Access Compliance Report Public Rights-of-Way (Curb Ramps)

Main Street: N PINE ST Cross Street: W 6TH ST Location: Intersection ID: 11796 N

Ramp Type: PerpDiag Initial Pass/Fail: Pass **Overall Compliance: No** Severity Score: 32.75 ADA ID: D0EE3862559C

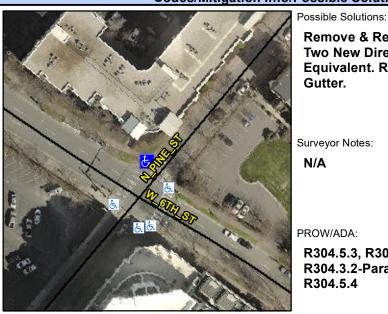
R304.5.3, R304.2.1, R304.2.2-Perp, R304.3.2-Para, R305, R302.7.2, R304.5.4

W 6TH ST Street 1 Name Stop Condition-Street 2 Signal Street 2 Name N PINE ST Stop Condition-Street 1 Signal Remove & Replace Curb Ramp With Two New Directional Ramps or Equivalent. Remove & Replace Gutter.
